**Ministry of Public Works
Department of Works and Engineering**

**Request for Proposals
For
Asphalt Plant Site Works
ADDENDUM 3**

Request for Proposals No.: **PN/2024-002-Q-AP**

ADDENDUM 3

Addenda 3 - SK-01

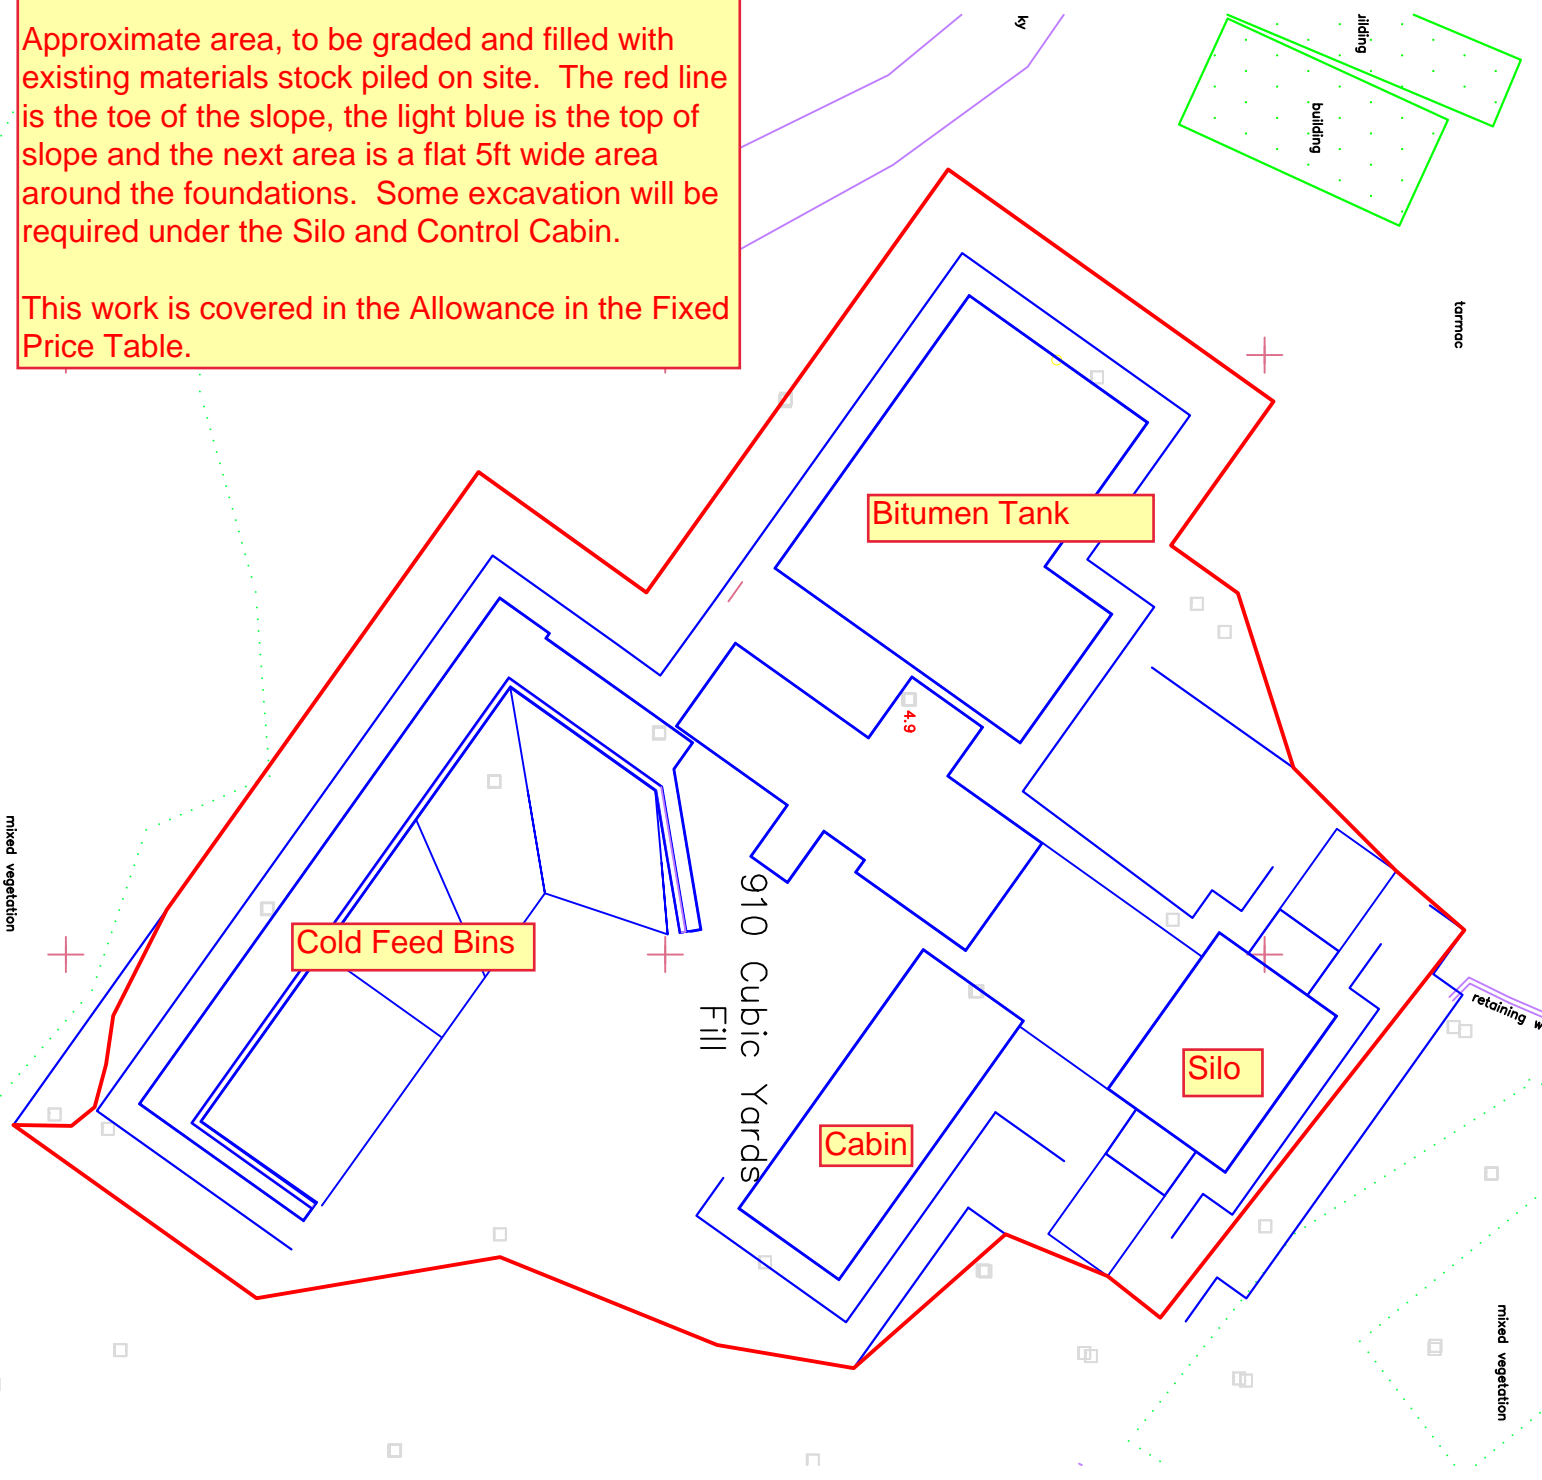
5. Sketch, SK-01 is attached which tries to show the extent of the grading for this project and an approximate volume of fill to be placed.
6. Item 3 has been broken down into the works required for each foundation as defined by the work on the drawings.

Approximate area, to be graded and filled with existing materials stock piled on site. The red line is the toe of the slope, the light blue is the top of slope and the next area is a flat 5ft wide area around the foundations. Some excavation will be required under the Silo and Control Cabin.

This work is covered in the Allowance in the Fixed Price Table.

REVISION: 0 SHEET No: S-303

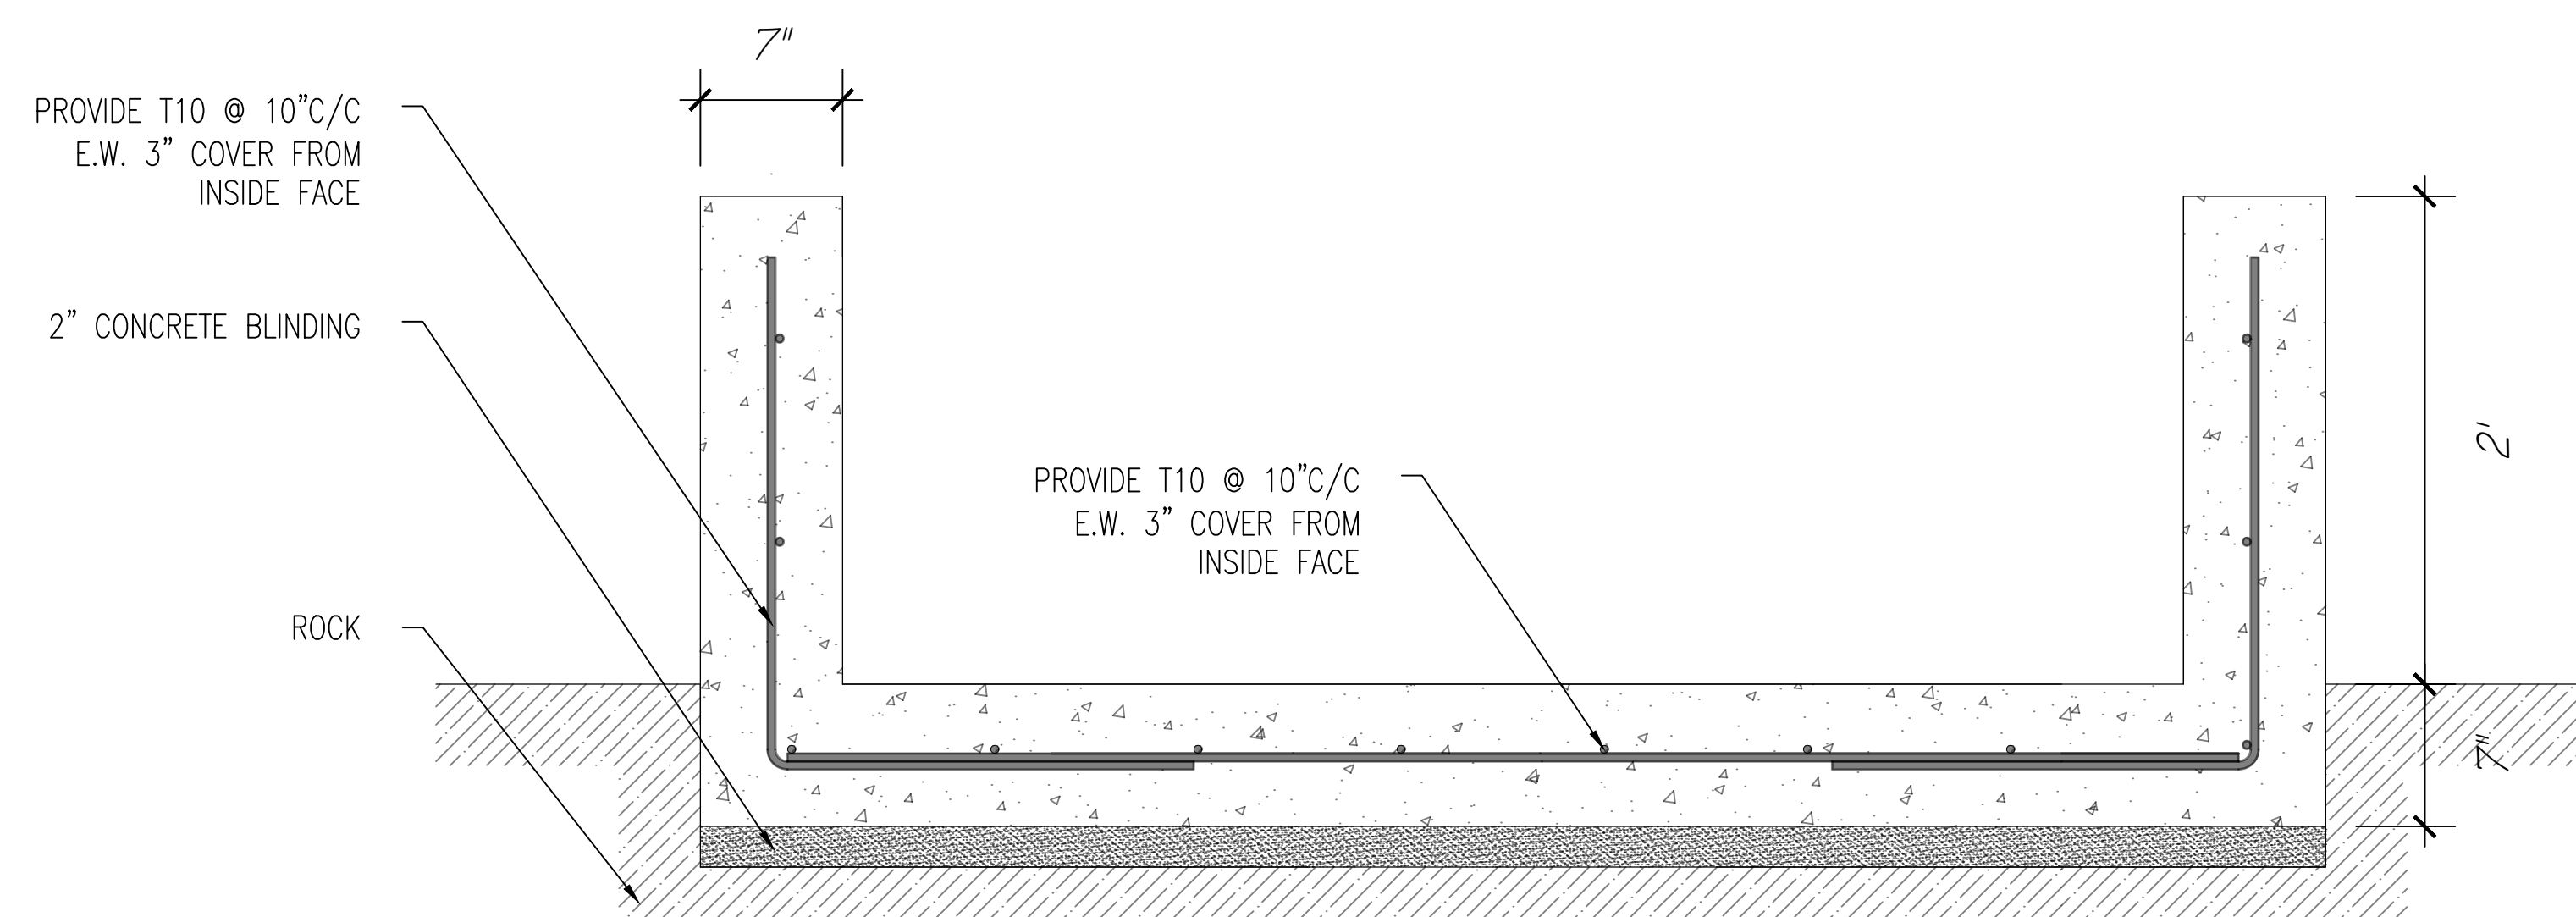
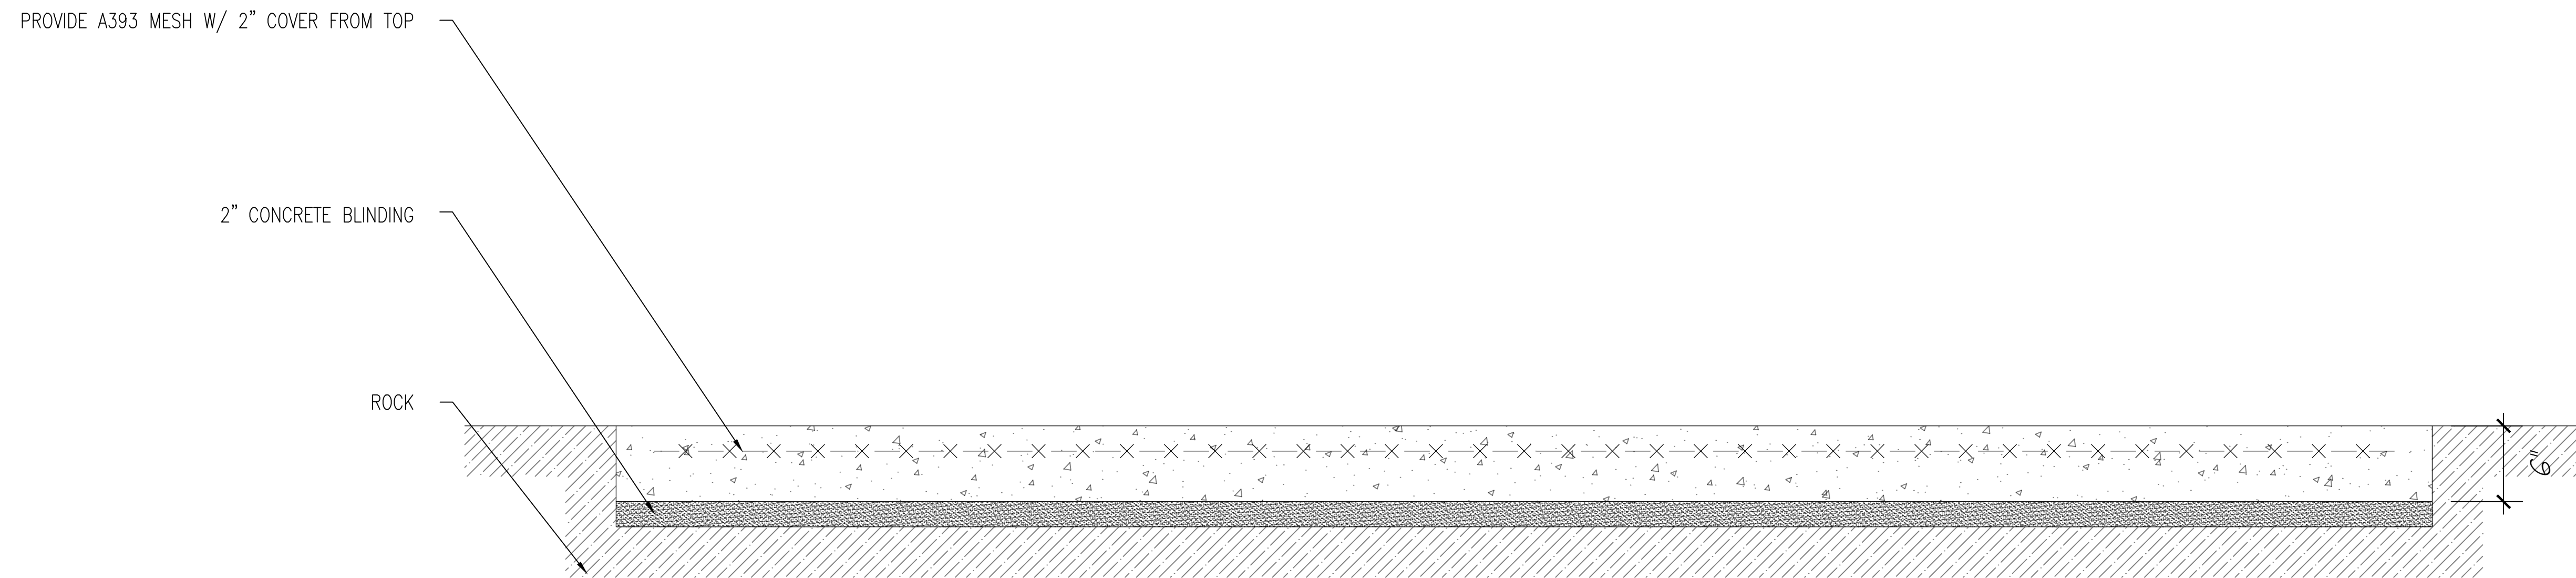
8. Drawing S-303 Revision 0, attached, the base slab and the walls will be 6" thick, and the slab shall be 25 feet long and 10 feet wide, out to out, or 9 feet clear between walls.
